CITY OF COCONUT CREEK

DEVELOPMENT REVIEW COMMITTEE (DRC) REVIEW #6 – SEPTEMBER 24, 2024

PROJECT NAME:	MainStreet Roadways		
PROJECT NUMBER:	PZ-22120002		
LOCATION:	Cullum Rd and Banks Road		
APPLICANT/AGENT:	HSQ Group		
REVIEW/APPLICATION:	PMDD Site Plan		
DISCIPLINE	REVIEWER	EMAIL	TELEPHONE
DRC Chair Urban Design & Development	Liz Aguiar - Principal Planner	laguiar@coconutcreek.net	(954) 973-6756
Sustainability, Urban Design & Photometrics	Linda Whitman – Sustainability Manager	lwhitman@coconutcreek.net	(954) 973-6756
Urban Design & Signage	Natacha Josiah - Planner	njosiah@coconutcreek.net	(954) 973-6756
Transportation	Michael Righetti - Senior Project Manager	mrighetti@coconutcreek.net	(954) 973-6756
Building	Sean Flanagan – Chief Building Official	sflanagan@coconutcreek.net	(954) 973-6750
Engineering	Eileen Cabrera - Senior Engineer	ecabrera@coconutcreek.net	(954) 973-6786
Fire	Ryan Banyas – Fire Marshal	rbanyas@coconutcreek.net	(954) 956-1563
Landscape	Scott Peavler - Landscape (consultant)	speavler@craventhompson.com	(954) 739-6400

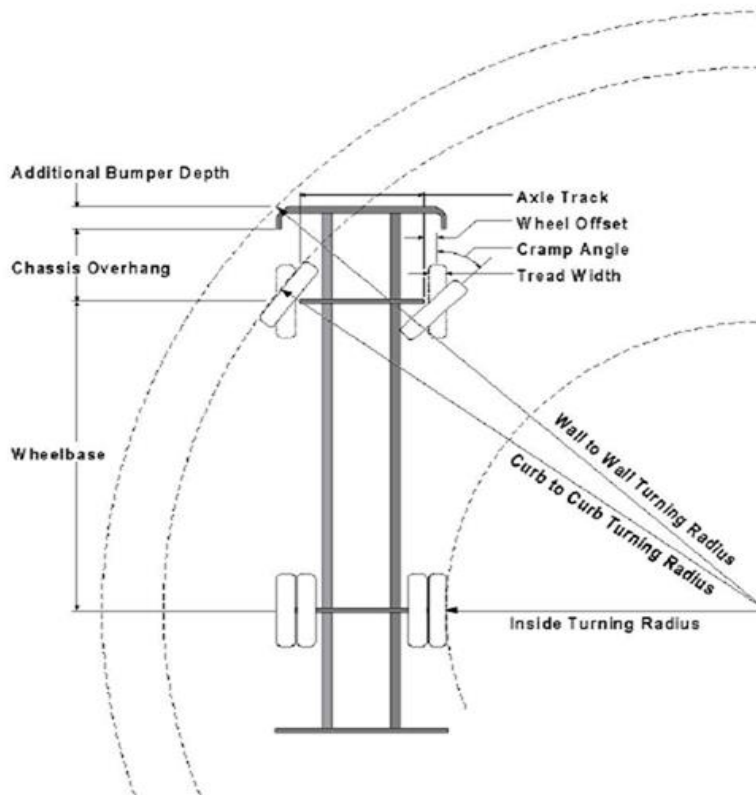
CLARIFY RESPONSE - WASN'T THE MEDIAN SHIFTED WEST (NOT EAST)...

EDIT SP-6 PLAN NOTE AT DRIVEWAY FOR CLARIFICATION?... "POTENTIAL ENTRANCE TO BLOCK 14 - FINAL LOCATION TO BE DETERMINED BY CITY)

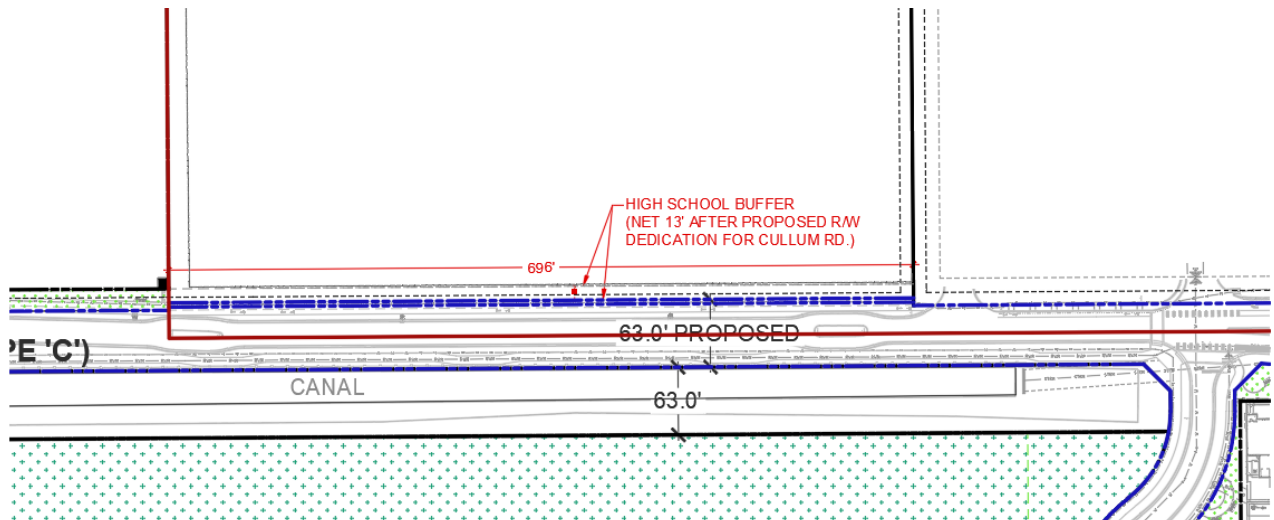
* North Side Palms & Trees to be provided within adjacent parcel buffer (High School Parcel) and adjacent parcel proposed greenway (City Civic Parcel).

* South Side Palms & Trees subject to coordination with Cocomar Canal Maintenance Requirements and compliance with City required utility separations.

The school buffer adjacent to Cullum Road is 696 linear feet X 13' width (after Cullum Road dedication of proposed 63' from centerline). 24 trees/palms are required (1/30 LF) and 3,619 shrubs/ground cover are required (40% of 9,048 SF strip) within the schools buffer.

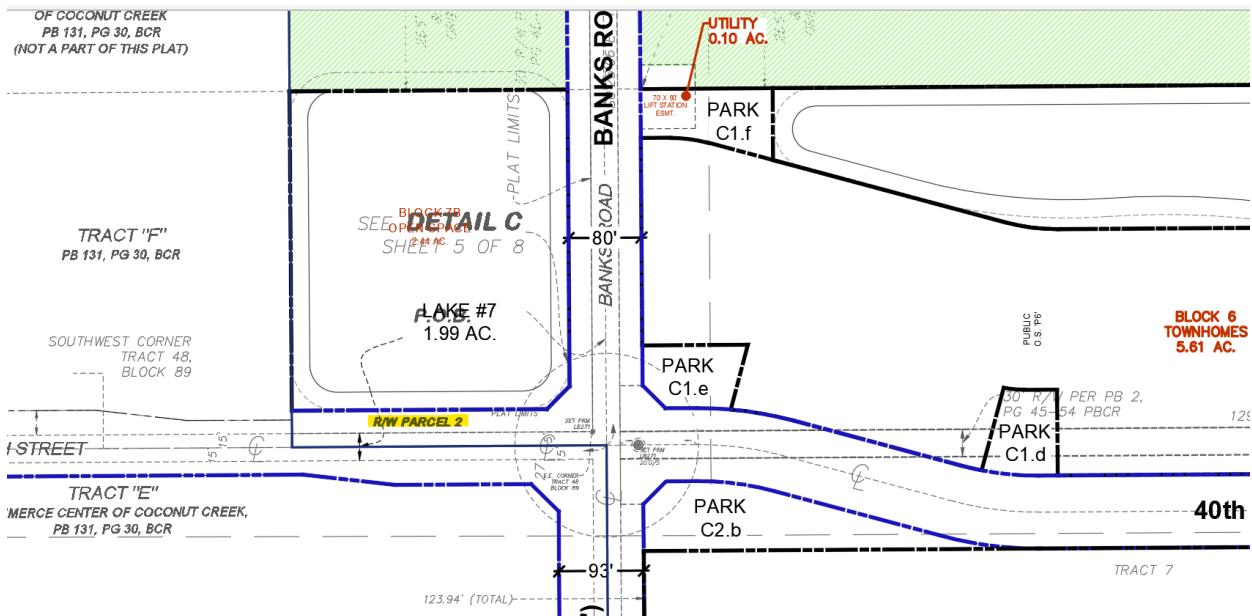
5. The Typical Roadway Section C-1 provides for 11.5 foot travel lanes on Cullum Road. This should be revised to provide EB Cullum Road with 10-foot travel lanes adjacent to Block 9. The additional 3-feet can be added to either the on-street parking, greenway/landscaping and/or the Cullum Road median.

RESPONSE: The roadway adjacent to the east portion of Block 9 at the intersection to 54th Ave. has been revised to 10’ wide lanes and added to the south side landscape strip. This allows the thru lane to align with Cullum road East of the intersection. The lanes at the west portion of Block 9 continue to taper to align with the existing wider travel lanes to the west of Mainstreet.

NW 54th Ave:

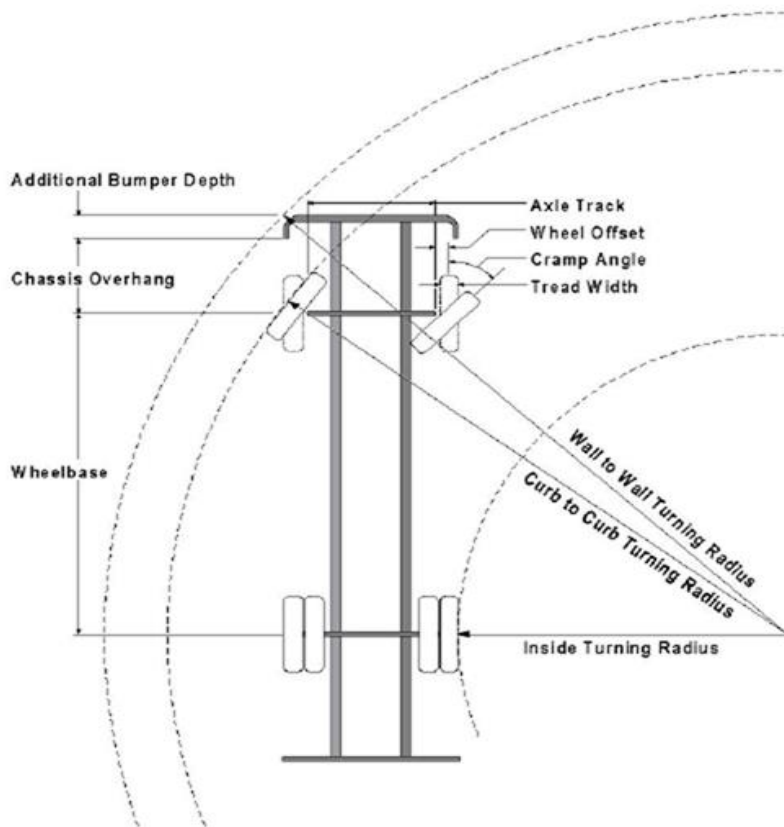
73. **(Tier 1)** Sheet SP-34: Please re-evaluate the left turn into the Seminole Casino and to possibly include a stop sign.

RESPONSE: As discussed with staff, the left turn movement is permissive and traffic will stop if there is oncoming traffic. As such, no stop sign is necessary.
